BENYA SOLAR PV AND ELECTRICAL GRID INFRASTRUCTURE DEVELOPMENT

COMMENTS & RESPONSES REPORT¹

DFFE REFERENCE NUMBER	DFFE Case Officer
14/12/16/3/3/2/2719	Ms Matlhodi Mogorosi

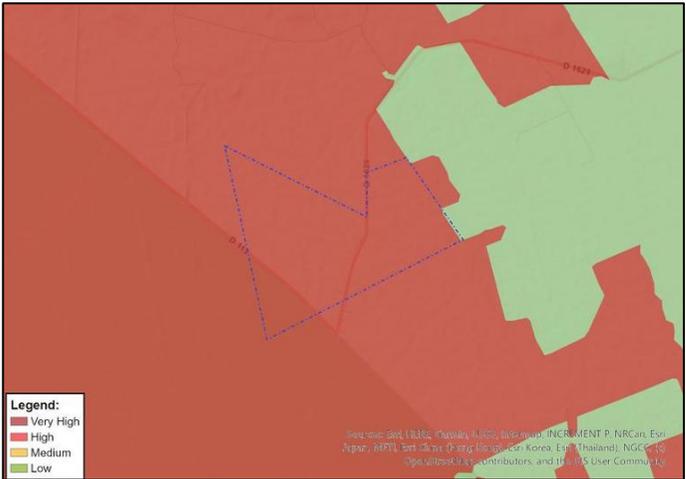
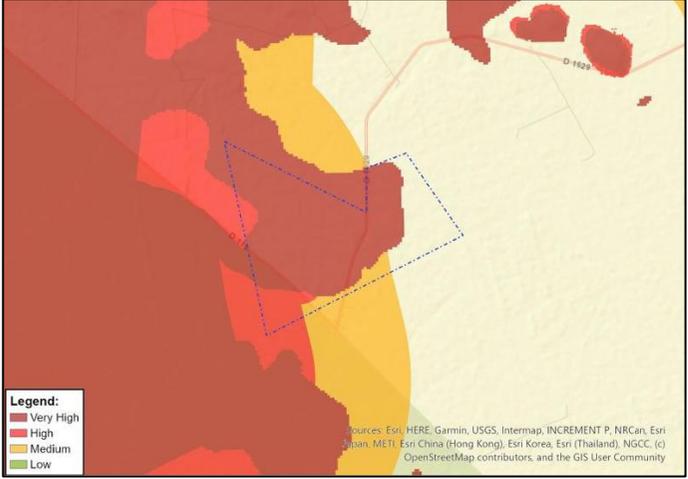
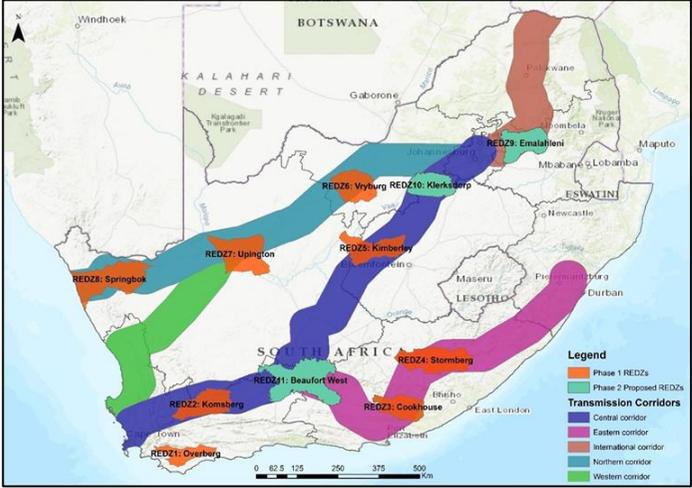
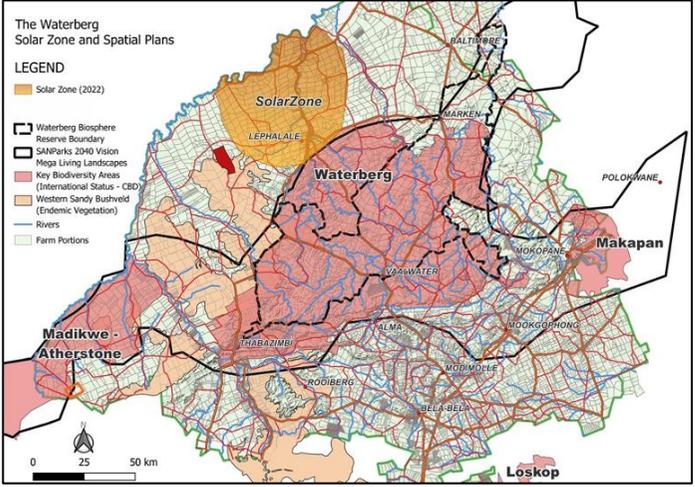
<p>2.2 Biodiversity Impacts have not been properly considered as required by the 2014 EIA Regulations: 2.2.1 The following represents the results of the screening for environmental sensitivity of the proposed site for various relevant environmental themes associated with the project classification. It is the duty of the EAP to ensure that the environmental themes provided by the National Web based Environmental Screening Tool (“the Screening Tool”) are comprehensive and complete for the proposed development. The majority of the environmental sensitivity themes for the proposed</p>	<p>The Terrestrial Biodiversity Assessment has been undertaken in accordance with the requirements per the Procedures for the Assessment and Minimum Criteria for Reporting on Identified Environmental Themes in terms of Sections 24(5)(a) and (h) and 44 of NEMA (GNR 320), as gazetted on 20 March 2020.</p> <p>The <i>“Procedures for the Assessment and Minimum Criteria for Reporting on Identified Environmental Themes in terms of sections 24 (5) (a) and (h) and 44 of the Act, when applying for Environmental Authorisation”</i>, as published on 20 March, 2020 in National Gazette, No. 43110 in terms of NEMA (Act 107 of 1998) sections 24(5)(a), (h) and 44, lists protocols and minimum report requirements for</p>

Date of comment, format of comment, name of organization/I&AP	Comment	Response from EAP
	<p>2.2.2 The Screening Tool identifies the Terrestrial Biodiversity sensitivity theme for the proposed development site as “Very High” sensitivity, as indicated in the image below, found on page 21 of the DSR:</p>  <p>2.2.2.1 The designation of “Very High” Terrestrial Biodiversity sensitivity theme is due to the entire development area being within a CBA 2 and ESA 2. This is noted and confirmed by the relevant specialist on page 92 of the DSR. Furthermore, as can be seen from the image above, the “Very High” designated portions of land stretch into the adjacent Madikwe Game Reserve, which further signifies the critical and sensitive environment of the site, both in terms of its own ecological value as well as to the greater surrounding area.</p>	<p>For the purpose of clarity, please note that the figure included under comment #2.2.2 is found on Page 91 of the DSR and not Page 21 as stated.</p> <p>Please see extract from the Terrestrial Biodiversity Scoping Report (Appendix E1 of the DSR) undertaken by Mr Jamie Pote who is registered as a Professional Natural Scientist in the field of Ecological Science with the South African Council For Natural Scientific Professions (SACNASP):</p> <p><i>“The proposed development site would not be considered irreplaceable, nor a critical connectivity corridor based on its position within the designated CBA areas and due to the vegetation unit not having an elevated conservation status”.</i></p>

<p>2.2.3 The Screening Tool also identifies the Visual and Landscape sensitivity theme for the proposed development site as “Very High” sensitivity, as indicated in the image below, found on page 88 of the DSR. According to the DSR, several sensitivity features were identified in the Screening Tool associated with the Landscape Theme. The DSR states</p>	<p>Seven (7) sensitivity features were identified in the DFFE Screening Tool associated with the Landscape Theme. The Screening Tool identifies the Visual and landscape sensitivity theme as “Very High”, in parts, but with portions of the study area consisting of “High” and “Medium” sensitivity areas. The “Very High” sensitivity is related to mountain tops and high ridges as well as within 250m of a river.</p>

Date of comment, format of comment, name of organization/I&AP	Comment	Response from EAP
	<p>development are regarded as “Very High” according to the Screening Tool.</p>	<p>environmental impacts on terrestrial biodiversity and provides the criteria for the assessment and reporting of impacts on terrestrial biodiversity for activities requiring environmental authorisation. This is detailed in Section 4.6: Appendix F: Site Sensitivity Verification Report of the Terrestrial Biodiversity Report and is also explained in further detail below.</p> <p>On 20 March 2020 the Minister of Forestry, Fisheries and the Environment (DFFE) published the general requirements for undertaking site sensitivity verification for environmental themes for activities requiring environmental authorisation (Government Gazette No. 43110). In terms of these requirements, prior to commencing with a specialist assessment, the current land use and environmental sensitivity of the site under consideration by the screening tool, must be confirmed by undertaking a site sensitivity verification by either an EAP or a specialist.</p> <p>In accordance with the applicable protocols or minimum information requirements, the Site Sensitivity Verification Report (SSVR) must confirm or dispute the site sensitivities for each of the themes identified in the Screening Tool Report. The SSVR must include a motivation for the exclusion of any of the specialist assessments identified in the Screening Tool Report which in the opinion of the EAP or specialist are not considered relevant or required.</p> <p>The report uses national datasets to identify site sensitivities and potential specialist studies that may be required for any particular development. Since the datasets are not necessarily ground-truthed, there are instances where the required specialist study confirms different sensitivities to those depicted in the screening tool.</p> <p>The verification of these sensitivities by the participating specialists is included in the Draft Scoping Report (DSR) under section 5.11.2. Please also refer to the site sensitivity maps included in section 2.11. of the DSR as well as the specialist SSVRs in appendices E1 – E6.</p>

Date of comment, format of comment, name of organization/I&AP	Comment	Response from EAP
	<p>that the “Screening Tool identifies the Visual and landscape sensitivity theme as “Very High”, in parts, but with portions of the study area consisting of “High” and “Medium” sensitivity areas. The “Very High” sensitivity is related to mountain tops and high ridges as well as within 250m of a river”.</p>  <p>2.2.3.1 The visual specialist confirmed the High sensitivity in the Screening Tool due to the steep slopes and mountain tops. The Applicant states that these areas will be avoided by the proposed development footprint and that the Medium sensitivity for areas between 3 and 5 km of a nature reserve was also confirmed.</p>	<p>The Visual Impact Assessment: Scoping Report (Appendix E6 of the DSR) confirmed the High sensitivity in the Screening Tool for the steep slopes and mountain tops. These areas will be avoided by the proposed development footprint. The Medium sensitivity for areas between 3 and 5 km of a nature reserve was also confirmed, while the remainder of the sensitivities were disputed.</p> <p>The statement made under comment #2.2.3.1 that “The visual specialist confirmed the High sensitivity in the Screening Tool due to the steep slopes and mountain tops” is therefore misleading, as the High Sensitivity confirmed by the specialist is only associated with slopes between 1:4 and 1:10 which is shown on Figure 5.16 of the Visual Impact Assessment: Scoping Report (Appendix E6 of the DSR). The remainder of the proposed development site has a Landscape Sensitivity ranging between Low-Medium. The High Sensitivity area for the steep slopes and mountain tops confirmed by the specialist will be avoided and no project infrastructure will be placed in this area, which will be confirmed in the preliminary site layout that will be presented in the Draft EIA Report and made available to registered I&APs and commenting authorities as part of the next round of public participation.</p> <p>Please also refer to Table 24 of the DSR summarising the confirmed/disputed sensitivity ratings associated with the Landscape Theme.</p>

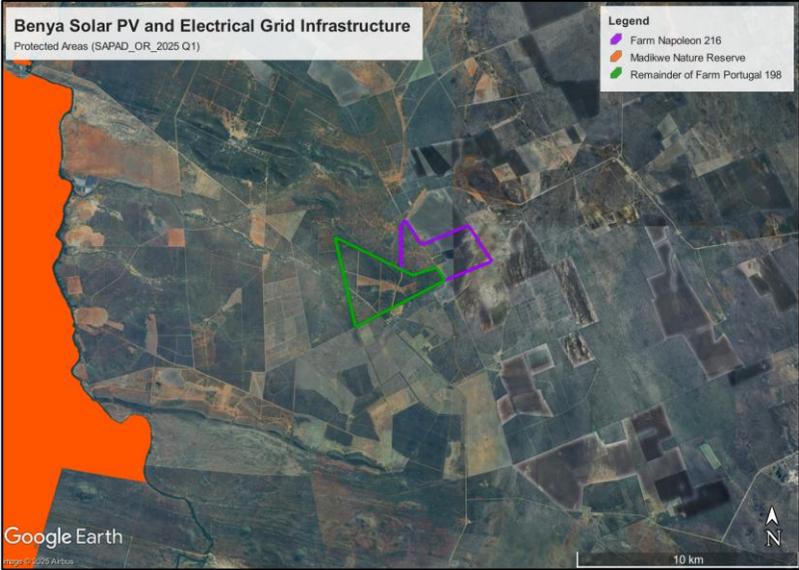
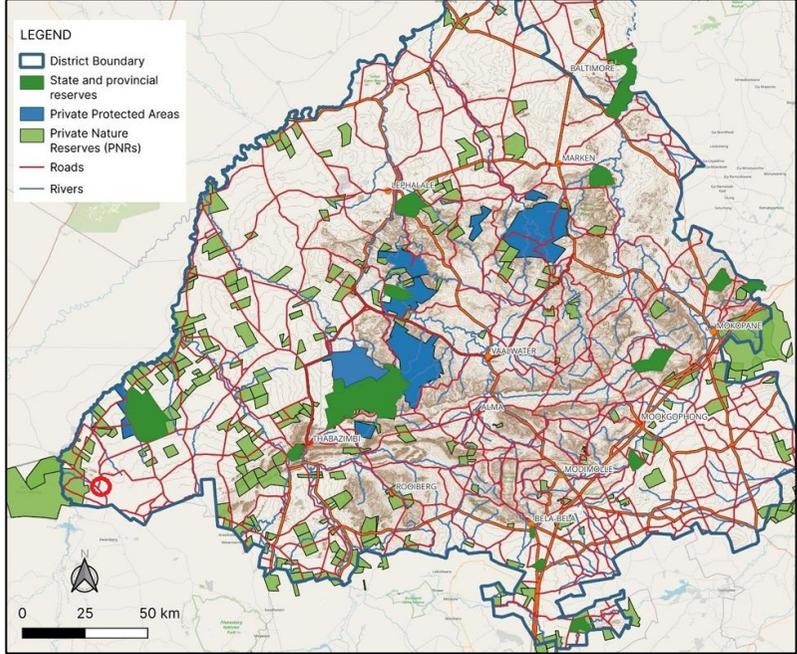
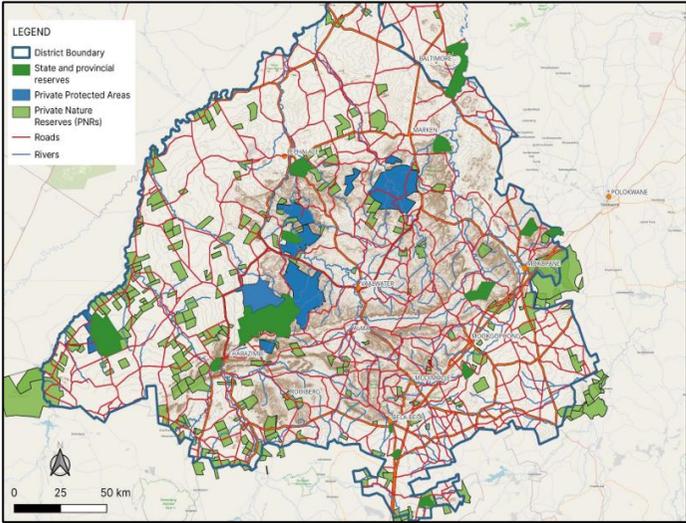
<p>2.3.2 As can be seen from the map above, no applicable REDZ exists in Limpopo aside from the international transmission corridor which runs through the central part of Limpopo Province. The applicant should</p>	<p>As mentioned in response to comment #2.3 above, is not always possible to acquire land within a Solar Industrial Development zone. The site would especially not be deemed suitable if it is not possible to feed the electricity generated into Eskom's</p>

Date of comment, format of comment, name of organization/I&AP	Comment	Response from EAP
	<p>instead have applied for authorisation for the proposed development in the Solar IDZ. The Solar IDZ is located north of Lephalale and is indicated on the Map, below:</p> 	<p>electrical network (either due to insufficient capacity being available within the existing electrical network or if no Eskom distribution or transmission infrastructure is situated within close proximity to the sites under consideration). In addition, the sites under consideration need to be suitable in terms of various factors (as detailed below) and if found to be unsuitable, a solar project would not be deemed feasible in these areas. The site selection process followed in detailed in the DSR and below.</p> <p>The site selection process followed a two-stage approach; firstly, to select the property for the proposed development (Remainder of Farm Portugal 198 and Farm Napoleon 216) and secondly, to select the footprint of the proposed development within the farm portion. Three (3) grid connection alternatives, which include three (3) alternatives for the substation location (including operational and maintenance infrastructure) as well as three (3) alternatives for a power line corridor (to connect to the existing Eskom OHL), are under consideration as part of this environmental process. The following main criteria were utilised to determine the position of the grid connection alternatives.</p> <ul style="list-style-type: none"> • Positioning along landscape and cadastral divides; • Positioning adjacent to existing infrastructure such as existing Eskom power lines and existing roads. <p>The grid connection alternatives are positioned on both the Remainder of Farm Portugal 198 and Farm Napoleon 216.</p> <p>The findings of the specialist studies and outcome of the public participation process will be taken into consideration and used to further inform the grid connection alternatives as well as the layout of the solar PV Facility. A layout for the solar PV Facility with preferred grid connection alternatives will be presented in the Draft Environmental Impact Report.</p> <p>The process undertaken by the Applicant for the identification of the project site was through an investigation of prospective sites and properties in the area. The</p>

Date of comment, format of comment, name of organization/I&AP	Comment	Response from EAP
		<p>investigation involved the consideration of specific characteristics within the Limpopo Province and specifically within the current study area.</p> <p>The criteria considered were identified by the Applicant as the main aspects that play a role in the opportunities and limitations for the development of a PV solar facility. The Applicant considered that should these criteria not be favorable for the development of a solar PV facility, then some limitations and challenges may be expected. The following criteria were taken into account by the applicant when selecting the properties for the proposed development of the Benya Solar PV Facility:</p> <p><u>The solar irradiation:</u> The economic viability of a solar PV facility is directly dependent on the annual solar irradiation at the site. As outlined in Section 2.9.2 of the DSR, the solar irradiation at the proposed site is favourable for commercial energy generation from solar PV.</p> <p><u>Land Availability:</u> To allow for the development of the Benya Solar PV Facility with a contracted capacity of up to 500MW, sufficient space for the placement of project infrastructure is required. The project site within the Limpopo Province and relatively close to the area of Dwaalboom was identified following the confirmation of the solar resource. The properties included as part of the project site/assessment area are privately-owned parcels available in the area that can be developed. The extent of the affected properties enables the consideration of a large area (i.e., 863ha) for assessment and for the placement of the development footprint. Furthermore, the willingness of the respective landowners to consent to the development on the affected properties was also considered by the Applicant.</p> <p><u>Proximity to towns with a need for socio-economic upliftment:</u> The proposed Benya Solar PV Facility is situated approximately 22km west of Dwaalboom and approximately 72km north-west of Northam in the Limpopo Province. Northam is a relatively large centre and consequently, local labour would be easy to source, which fits in well with the Renewable Energy Independent Power Producer Procurement</p>

Date of comment, format of comment, name of organization/I&AP	Comment	Response from EAP
		<p>Programme (REIPPPP) economic development criteria for socio-economic upliftment.</p> <p><u>Access to national electrical grid:</u> Ease of access into the Eskom electricity grid is vital to the viability of a solar PV facility. Projects which are in relatively close proximity to a connection point and/or demand centre are favourable, and reduce the losses associated with power transmission. The project site is within very close proximity of the existing Spitskop-Gaborone South 2 132kV OHL on Farm Napoleon 216, which makes a Loop-In Loop-Out (LILO) connection possible.</p> <p><u>Current land use:</u> The Agricultural specialist has confirmed that the cropping potential of the project site is limited to the corridors that will be utilised for the LILO connection to the existing Spitskop-Gaborone 2 132kV OHL. Due to the LILO corridor consisting of linear infrastructure, it will have negligible agricultural impact. The entire proposed PV development will be placed outside the high agricultural sensitivity land. The rainfall is very marginal for crop production. The soils are very shallow and consequently have very low water and nutrient holding capacity. The low water holding capacity, in combination with the rainfall, provides an insufficient moisture reservoir to reliably carry a crop through the season. The climate and soil constraints mean that the assessed area is not suitable for continuous, profitable crop production.</p> <p><u>Proximity to access road for transportation of material and components:</u> The proximity of the site to the well-maintained existing road network (including existing D113 and D1629 roads) decreases the impact on secondary roads from traffic during the construction and operation phases.</p> <p><u>Landowner support:</u> The selection of a site for the PV development where the landowner is supportive of the development of renewable energy is essential for ensuring the success of the project. The landowner of the solar PV property does not view the development as a conflict with the current land use practices and has provided written consent for the proposed Benya Solar PV Facility (please refer to</p>
